### **Product Change Notification**

#### PCN-FDC-6791-2021

Business Unit	Product Line Code	Type of Change	Action	Date of Issue
FDC - Field Device	ABQ	Product Change	Notify Distributors and	4/28/2021
Connectors		Notification	Field

### Description for Product Change Notification

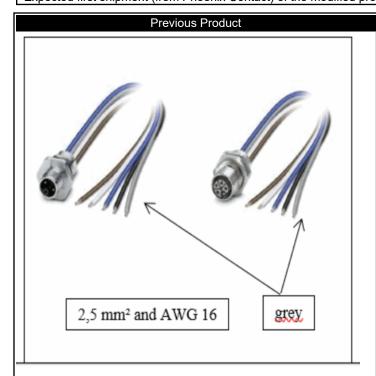
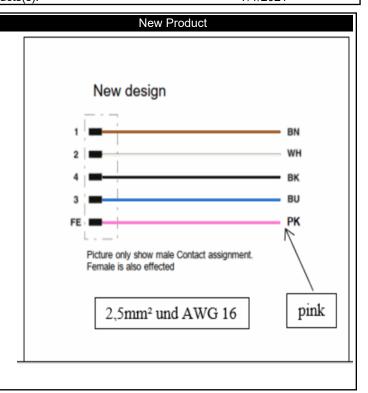
For L-coded M12 flush-type connectors, in accordance with the attached item list, the wire color of the FE position for the 14 AWG wire and 16 AWG wire will change from gray to pink, in conformity with an update to the standard DIN EN 60445. The change will start in the first half of 2021. During this period, mixed deliveries are possible. We expect to deliver all affected items with the changed design starting on 2021-07-01. No other technical or electrical data of the items will be affected by this change. With this product change, due to the PROFINET standard and its user organization (PNO) and the resulting

adjusted approval conditions, we are meeting the market and customer requirements early on. The change also affects the L-coded M12 cable connectors and conductors. An individual PCN has also been created for this.
